ST MARYS CHURCH HULME

PLANNING RESPONSE 11.02.26

This response follows comments raised by the Conservation Officer in December 2025 and responds to discussions held on site on January 13th 2026

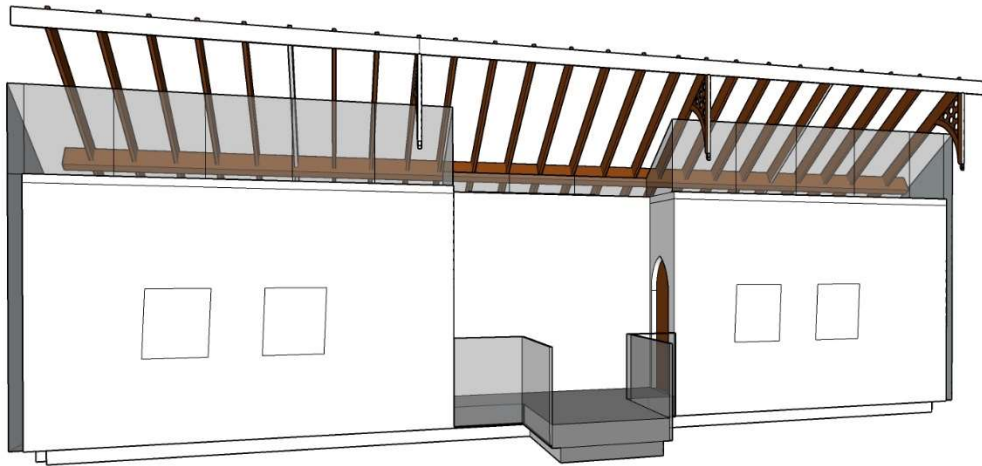
Another disadvantage is that the glazed wall may restrict the layout of furniture, particularly on the south-west corner bedroom where there are already two low level external windows. This would result in the headboard having to be on the partition wall facing the main central space.

However, the use of full height glazing, or even long runs of glass that were say at a standard ceiling height, does not give the client the look and feel they are after and, in their opinion, would look more commercial than domestic. As discussed previously, the lack of wall space would also restrict the display of their art collection which is an important consideration of their brief.

We are therefore proposing to retain the bedroom and bathroom partitions as blank plasterboard walls that can be used to display artwork or feature wallpapers or to place furniture against and have proposed a glazed clerestorey above them along with some slot glazing at the junction with the cross walls.
